**BOTLEY WEST SOLAR FARM
OXFORDSHIRE HOST AUTHORITIES
RESPONSE TO ISH2 ACTION POINT 16
DEADLINE 6 | MONDAY 20 OCTOBER 2025**

OXFORDSHIRE HOST AUTHORITIES RESPONSE TO ISH2 ACTION POINT 16

OHA to provide clarification note regarding further reductions to solar installation, the methodology used to define those areas for reduction and the impacts you feel remain.

Change Request 2 - Areas for panel Removal

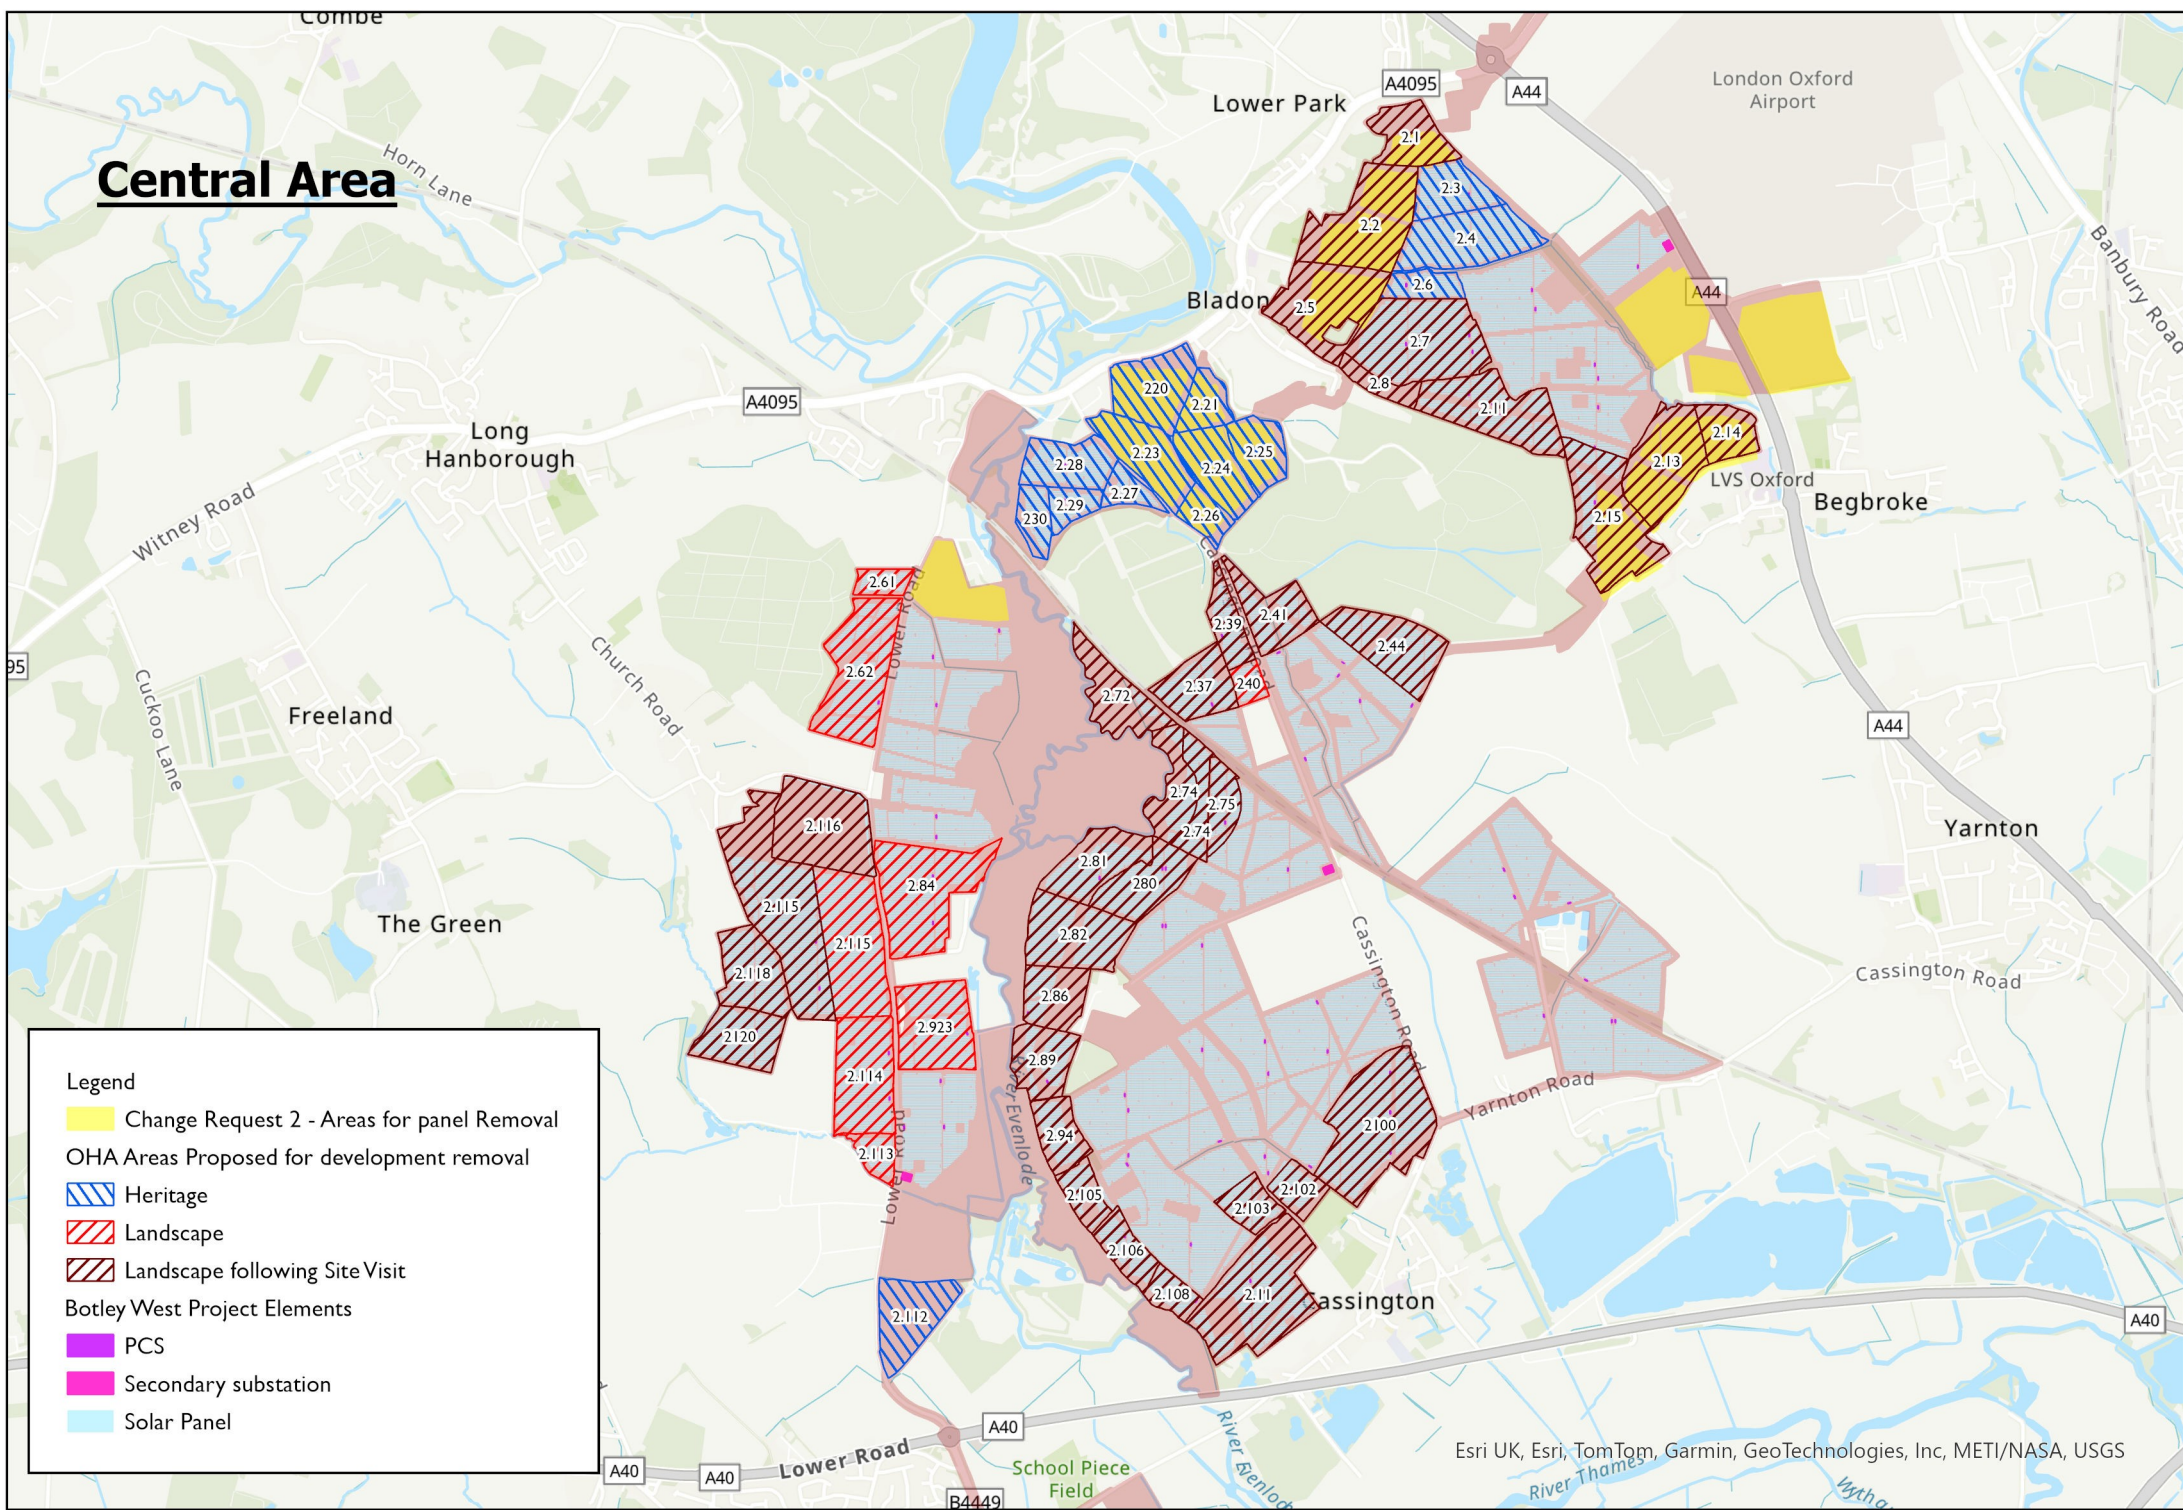
The following table sets out the rationale for the recommendations made. They highlight development parcels which would fall across areas of higher landscape, visual, residential visual amenity or heritage sensitivity (for the reasons stated), and which should be removed from the development in order to reduce effects.

1.11 (part of)	Nr Sansom's Farm	9, 10 (distant)	Note that no panels are proposed in the southern part of the field, as it has been identified as an area of Archaeological Interest on the applicant's masterplan [CR2-026]	<p>Panels should be removed from the lower ground, up to the break in slope, and a line drawn running east-north-east from Hordley Farm.</p> <p>Reason: to reduce effects upon residential visual amenity in the views east from Hordley Farm, where effects are likely to be considered overbearing.</p>	x	x

1.12	Nr Sansom's Farm and Hordley House	8, 9,		<p>Small areas of outlying panels on elevated land, either side of footpath. Panels would be isolated from the rest of the development as the remainder of field 1.12 has been identified as an area of archaeological interest on the applicant's masterplan [CR2-026]</p> <p>Reason: to reduce effects upon residential visual amenity, in the views south from Hordley Farm, where effects are likely to be considered overbearing; and to reduce effects on users of the footpath.</p>	x	x

Parcel No.	Location	Relevant Viewpoints (VPs)	Site Character/ Notes	Explanation	Reasons for Removal	
					Landscape/ Visual/Residential	Heritage
1.13	Nr Sansom's Farm and Oxford School of Drama	9, 11, 12 (distant)		<p>Areas of outlying panels on elevated land. Panels would be isolated from the rest of the development as the remainder of field 1.13 has been identified as an area of archaeological interest on the applicant's masterplan [CR2-026]</p> <p>Reason: to reduce effects upon residential visual amenity, in the views south from Sansom's Farm, Sansoms Cottage, Sansom's Platt Farm, where effects are likely to be considered overbearing; and to reduce effects on users of the Oxfordshire Way footpath which runs along the course of the Roman Road, now reflected as Stratford Lane. Also, to remove panels from the steep ground which drops down to the River Glyme and the sloping ground which drops down to Sansom's Platt. Panels would be more widely visible when located on steeper slopes, and would visually conflict with the topography.</p>	x	x

1.14	Nr Sansom's Farm	11, 13	Note that there is an existing solar development at the southern end of field, with which there would be cumulative effects	<p>Areas of outlying panels on elevated land. Panels would be isolated from the rest of the development after archaeological areas have been removed. The north east of field 1.14 has been identified as an area of archaeological interest on the applicant's masterplan [CR2-026]</p> <p>Reason: Reduce potential for overbearing effects on the residential visual amenity of Weaveley Farm.</p>	x	x

1.17 (south-eastern third)	Nr Shipton Slade	No VPs		<p>Removal of panels to link into ground levels and area of archaeology. Setting and views to and from Shipton Slade Farm.</p> <p>Reason: to reduce effects upon residential visual amenity, in the views north-west from Shipton Slade Farm, which is an area very close to the windows and gardens of properties within this historic hamlet, where effects are likely to be considered overbearing.</p> <p>Also, an area which is potentially visible from the area of the Column of Victory within Blenheim Park, noting that the Column of Victory can be seen from here.</p>	x

1.18 (southern half)	Nr Shipton Slade	No VPs		<p>Removal of panels from setting and views to and from Shipton Slade Farm. Removal of isolated field of panels, if areas to west of Shipton Slade Farm are removed.</p> <p>Reason: to reduce effects upon residential visual amenity, in the views north-east from Shipton Slade Farm, which is an area very close to the windows and gardens of properties within this historic hamlet, where effects are likely to be considered overbearing.</p>	x
